UNITED STATES PATENT AND TRADEMARK OFFICE

APPLICATION NO.	FILING DATE	FIRST NAMED INVENTOR	ATTORNEY DOCKET NO.	CONFIRMATION NO.
10/517,997	06/29/2005	Hyo-Young Bae	1455-045908	1604

Office Action Summary	Application No. 10/517,997	Applicant(s) BAE ET AL.	
	Examiner EVAN H. LANGDON	Art Unit 3654

DETAILED ACTION

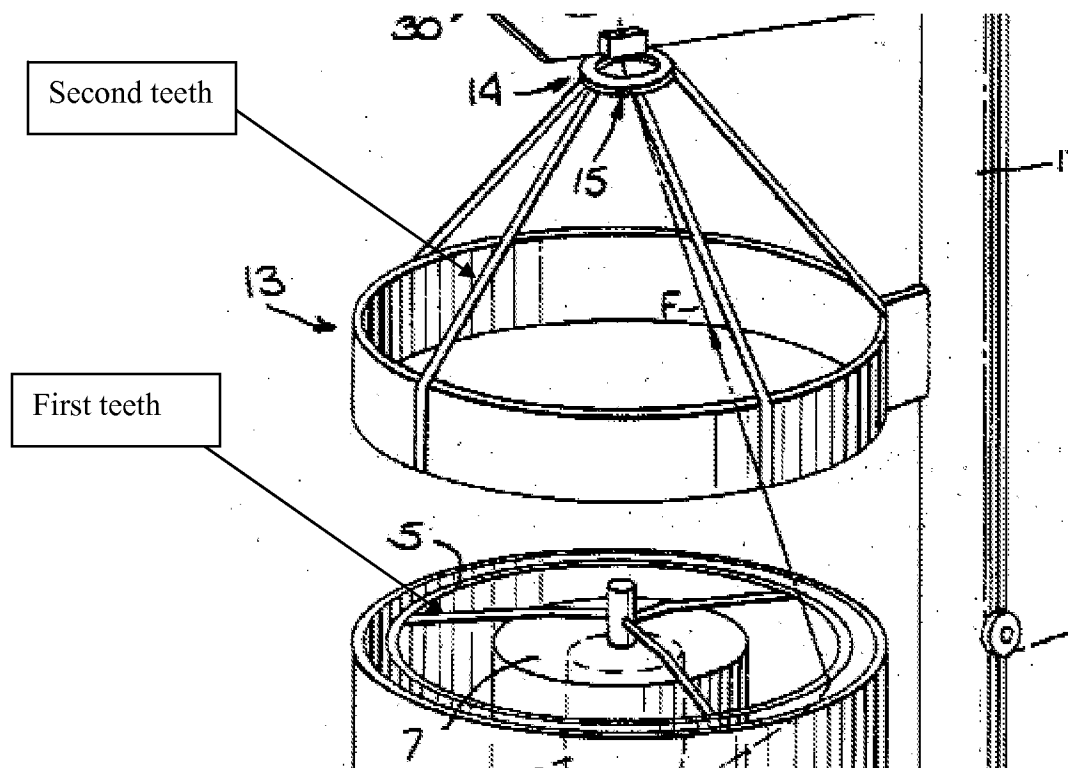
a ring member (5,13,14) laid on a top surface of the tube-shaped wound body (Z), the ring member (5) including an outer ring (5) having an outer diameter smaller than an inner

diameter of the pail pack (4), and an inner ring (14) having an outer diameter smaller than an inner diameter of the outer ring (5);

a plurality of first comb teeth (Fig. 1, below) extending from an inner circumferential surface of the outer ring (5) toward the inner ring (14); and

a plurality of second comb teeth (Fig. 1, below) extending from an outer circumferential surface of the inner ring (14) toward the outer ring (5),

In regard to claim 2, Bellasio discloses the first comb teeth (see above) of the outer ring (5) have a length smaller than that of the second comb teeth (see above) of the inner ring (14).

In regard to claim 3, Bellasio discloses the first and second comb teeth (see above) are alternately arranged.

In regard to claim 4, Bellasio discloses each of the first and second comb teeth (see above) has a flat strip structure.
